Re: Draft 1 Version 3.0 ENERGY STAR Audio/Video Specification

The Proposed Draft 1 Proposed Test Method Does Not Reflect Real-World Operating Conditions and, therefore, Overestimates Amplifier Power Consumption and Misdirects Energy Efficient Product Designs

**BOSE CORPORATION:
VOLUME VERSUS TIME USAGE MODEL DATA**

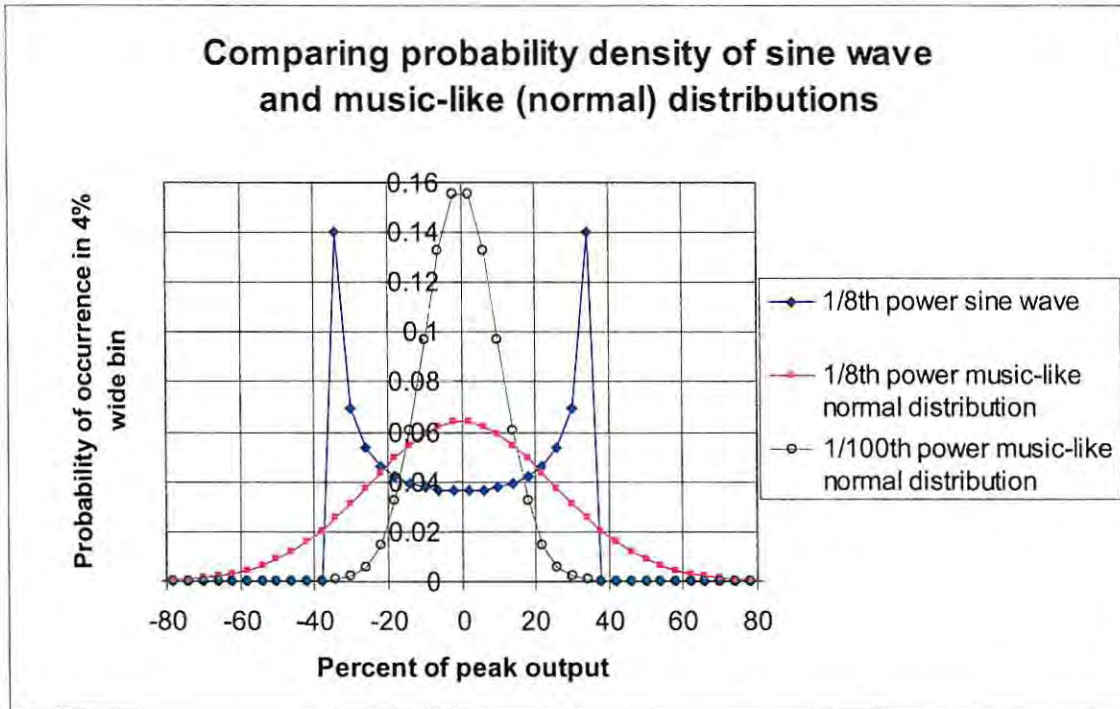
For each volume control range, the average audio power to the speakers has been measured using music which was specifically selected to have near-mean audio demands (voice and movie material exhibit lower average audio power demand than music). By weighting the average audio power delivered to the loudspeaker in each volume range by the fraction of time that each volume range was used, Bose learned that the average speaker power consumed when the unit was playing was less than ½ watt! The detailed data is shown in the Table below. Since most audio amplifiers exhibit MUP significantly greater than 4 watts, we can say with confidence that **typical listening is done at power levels significantly less than 1/8th power.** Thus, **measuring at 1/8th power is not consistent with customer behavior and overestimates the amount of power consumed by amplifier products under real-world operating conditions.**

As an alternative method, Bose recommends that the ENERGY STAR A/V Specification test method should **adopt idle power** as the measured and specified attribute **that represents the product in use, while playing audio.** The actual use case of audio amplifiers in homes is quite
